V8 XJ Series/XK

TECHNICAL BULLETIN

Door Latch Issues – Door Ajar Switch Now Available Separately – Replacement Procedure

MODEL
1997 MY-ON XK8 Range
1998-2003 MY V8 XJ Series
VIN
001001-ON
812256-F59525

ILLUSTRATION 1

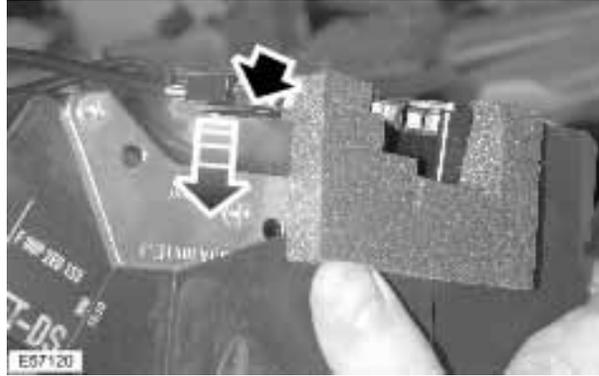
5. Press the retaining tang and remove the switch from the door latch (Illustration 1). Note orientation of the switch in the door latch for assembly purposes.

ILLUSTRATION 2

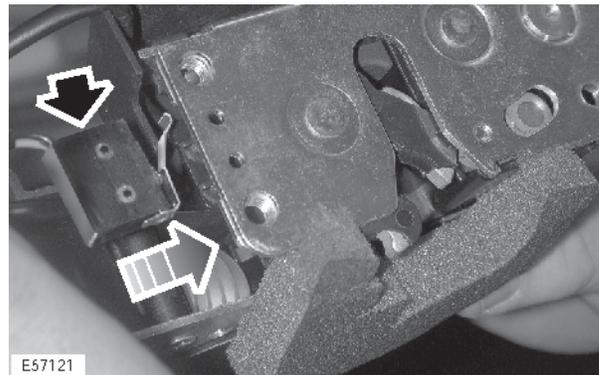
6. Install and seat the new switch to the door latch. Ensure that the switch is installed in the correct orientation and that the locating pegs are engaged (Illustration 2).
